An Coimisiún Pleanála

3rd Party Appeal

We have been instructed by Mrs. Karen Hehir to lodge a 3rd party appeal on the split decision for the proposed development of 10 Longford Terrace, Monkstown, A94XY98 the subject of D26A/0068/WEB in particular the decision to Grant Permission to:

Planning Reference Number: D26A/0068/WEB

Extracts from the application drawing (P) 200

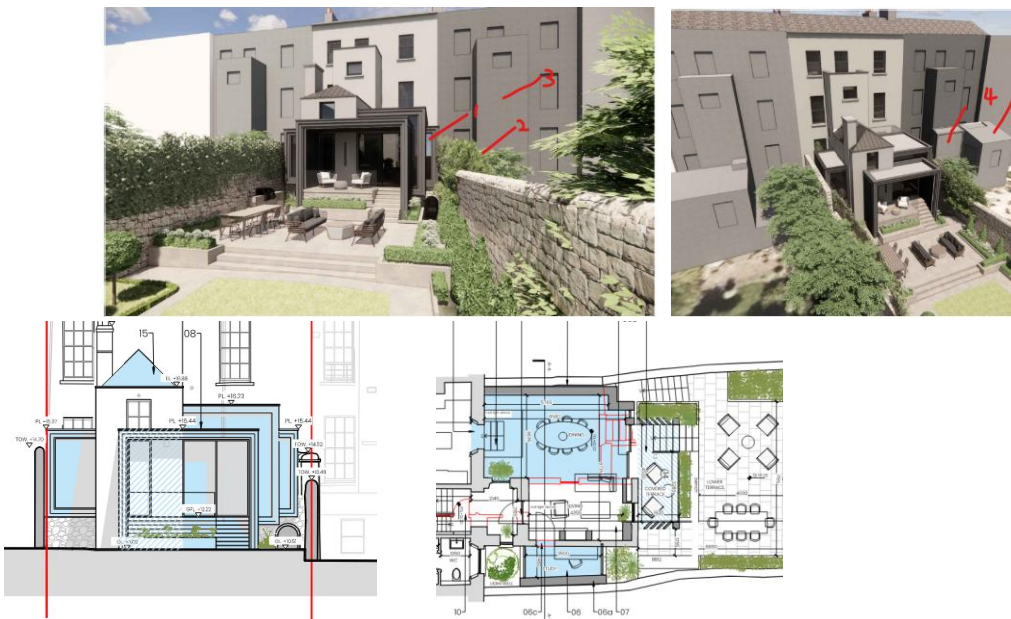
- The proposed drawing P200 has three-dimensional imagery in the bottom right corner. The vegetation shown on the boundary to number 11 does not exist and cannot exist as it is hard landscaping on both sides of the party wall.

Existing condition looking down on party wall from number 11 to number 10. There is nowhere for vegetation shown in the imagery to grow (2 in image below).

- The modelling of number 11 shows an extension to the vertical return and a second lower extension. Neither of these exist (4). It doesn't show the arched window (3). This is relevant as the height of the new roof to the original extension to 10 is above this level.
- The 3d imagery shows glazed connections between the different stepping frames. This is confirmed in internal imagery also. The plan shows these as solid. If the glazing was installed at the rear elevation as shown (1), then the floor level at this point would provide a direct view into number 10 creating potential privacy issues (1). The plan, elevations and the 3d imagery do not appear to match.

- Sunlight, daylight and shadow analysis uses the flawed 3d model for its analysis. In particular windows 2.0.2 and 2.1.2 do not correctly represent the actual windows and 2.0.3 and 2.0.4 are not windows but are open sides of a canopy on the terrace. I have commented on the analysis below.
